**LEGAL ADVERTISEMENT
PORTLAND PLANNING BOARD MEETING**

To: Elizabeth Boepple, Chair, and Members of the Portland Planning Board
From: Shukria Wiar, Planner
Date: January 13, 2017
Re: 161 York Street
Project #: 2016-261 **CBL:** 044 B 006
Meeting Date: January 17, 2017

York Street Development LLC has requested a preliminary Level III site plan and subdivision review of an eleven-unit urban infill development at 161 York Street near the Casco Bay Bridge and State Street. The proposed 11,046 SF development includes a five-story multifamily building with parking at two different levels, as well as surface parking spaces. The site will be accessed from York Street and Guilford Court. The vacant lot was previously occupied by two 2-story residential buildings that have recently been demolished. The site is within the R-6 zone and within 100 feet of the West End Historic District.

BUILDING
ELEVATION
3/32" = 1'-0"

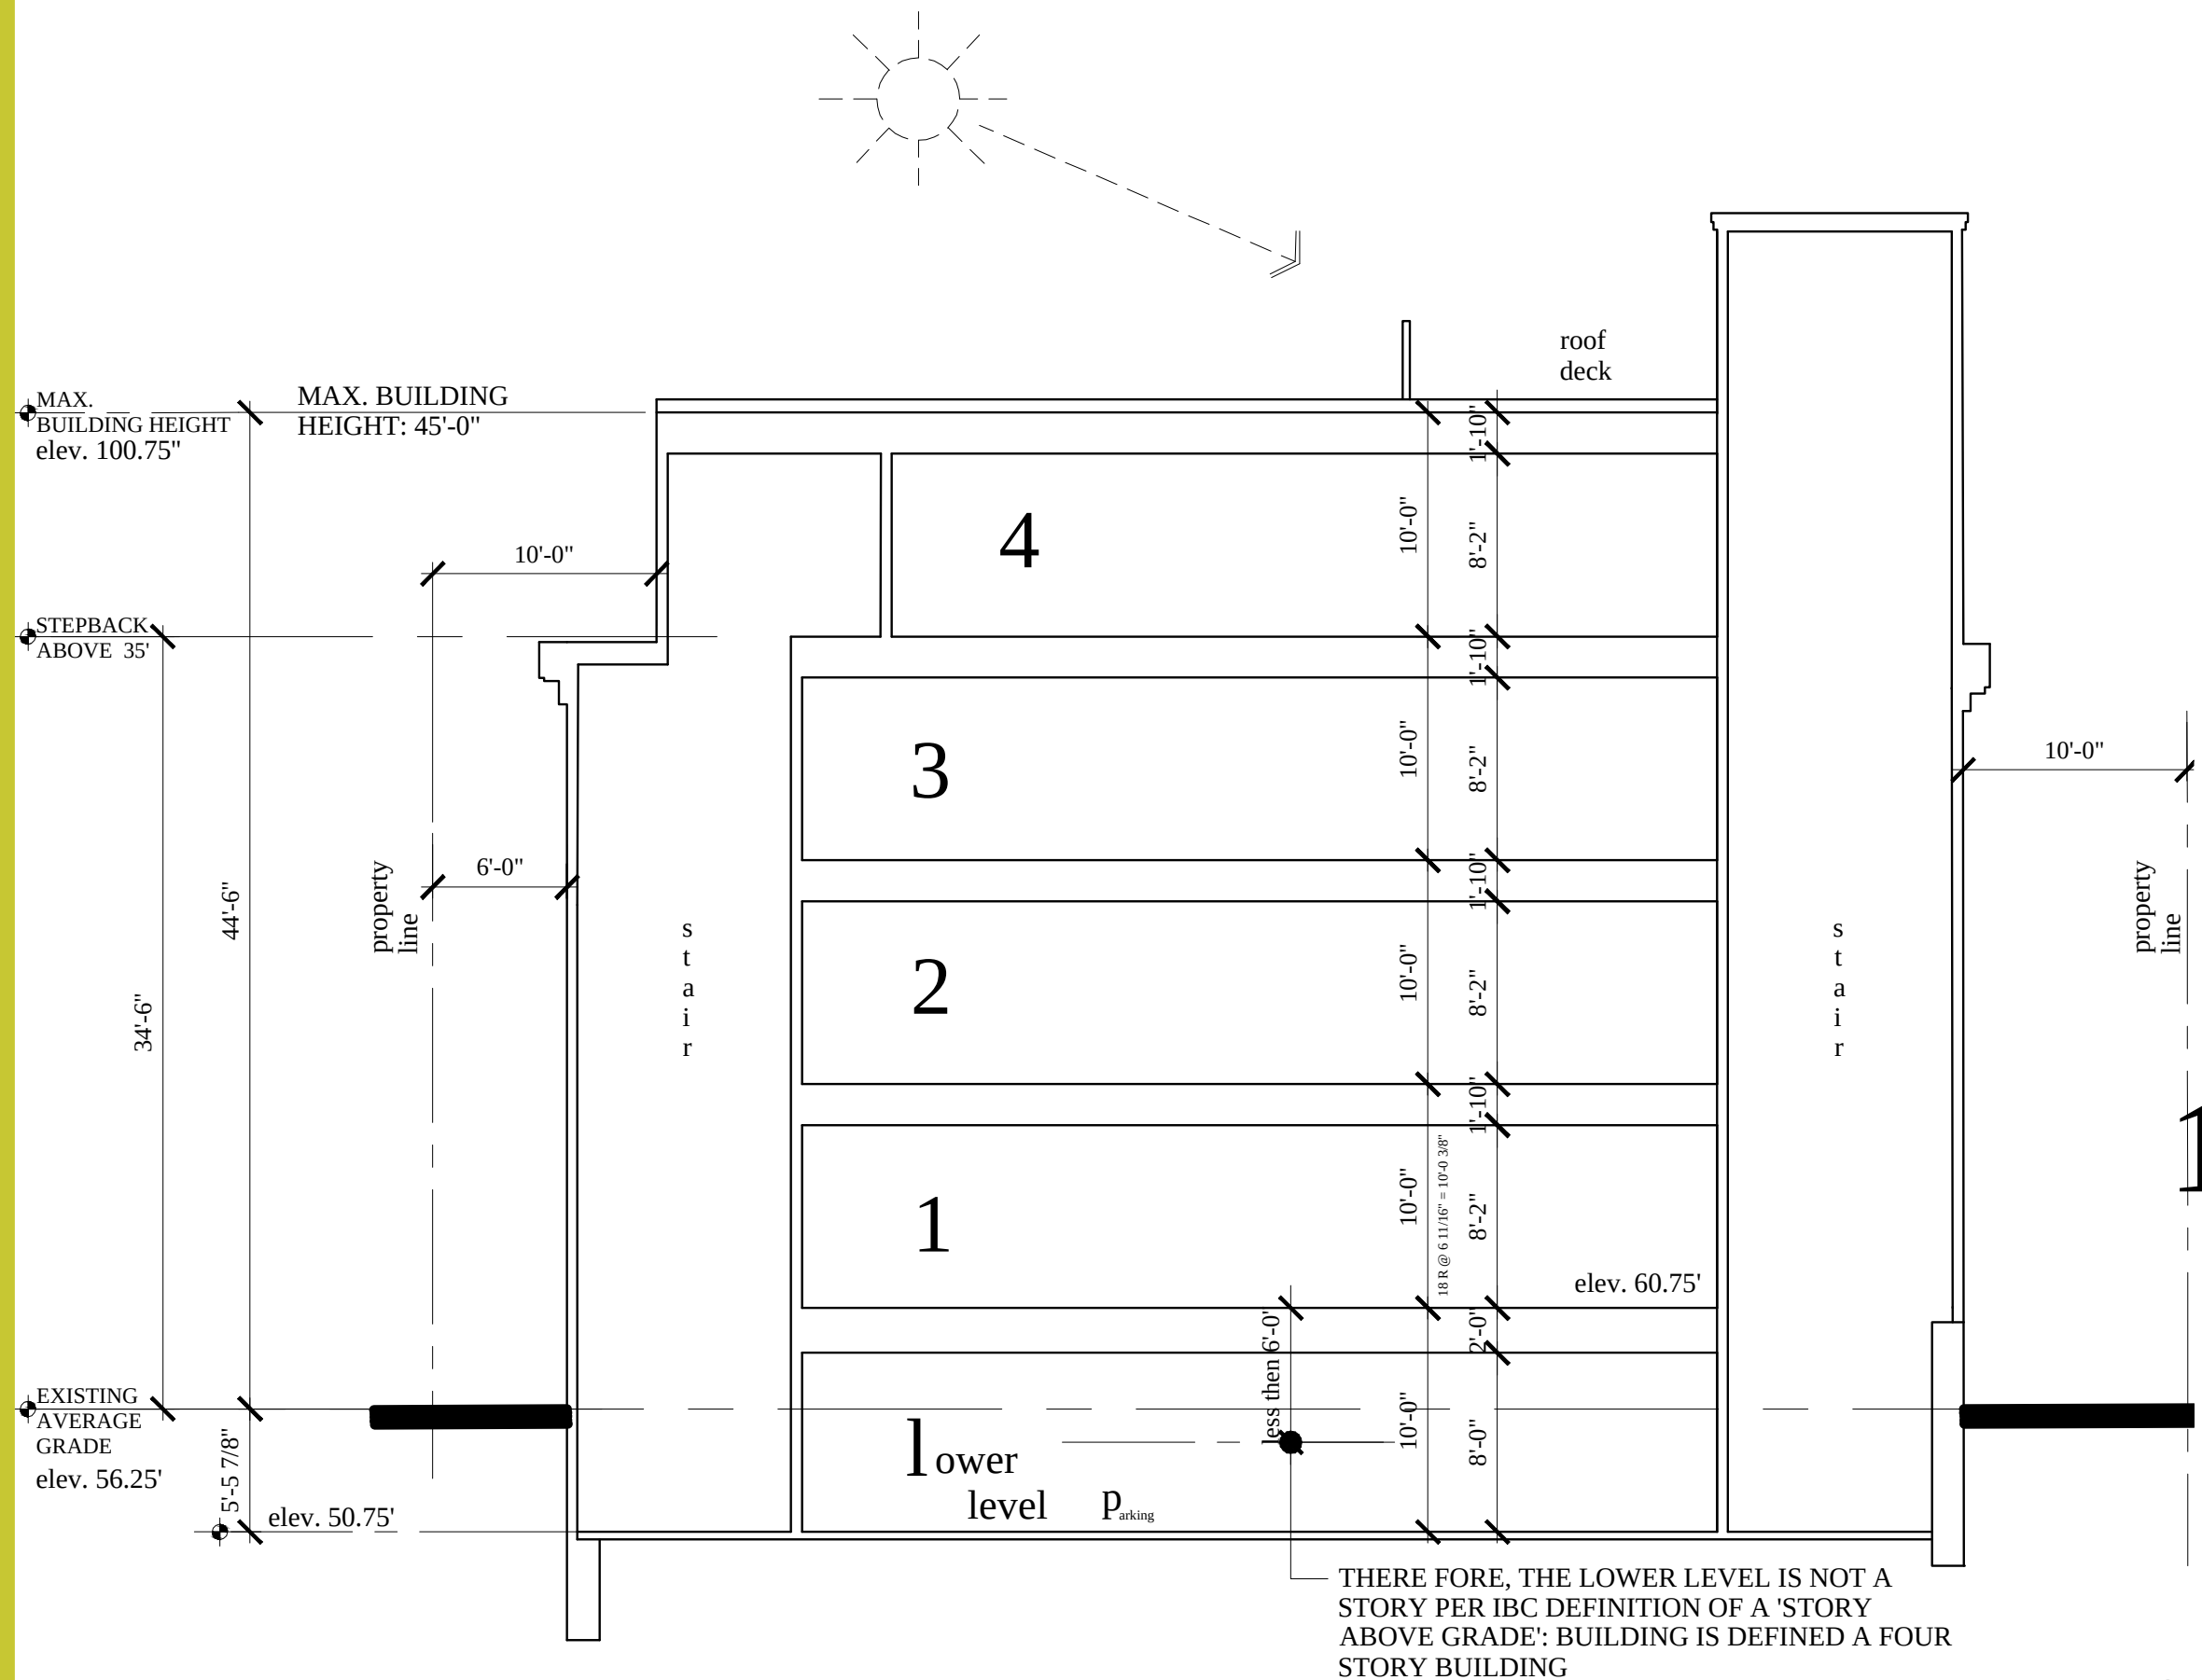
Staff Comments- *The project employs only one of the articulation elements required – covered entry. The balconies are too small to meet the required sf. Staff recommends that the design be modified to provide a more pronounced recess or projection where the balconies are currently located. Refer to 62 State Street as an example.*

Staff Comments- *Remove the “dentals” shown at the 4th floor cornice. More information is needed about the window reveals.*

- *F-2 Window Types*
Staff Comments- *Three window types at street façade. The ground floor windows imply living spaces – revise to reflect garage (smaller, higher windows, or use of grates).*
- *F-6 Main Entries*
Staff Comments- *The main entry is requires more emphasis.*
- *F-7 Articulation Elements: A cornice is provided at the fourth floor and appear to be at least 6”;* *no other façade offsets are provided.*
Staff Comments- *To meet standard B-5, either recesses or bay projections of at least 12” are required on the front façade.*
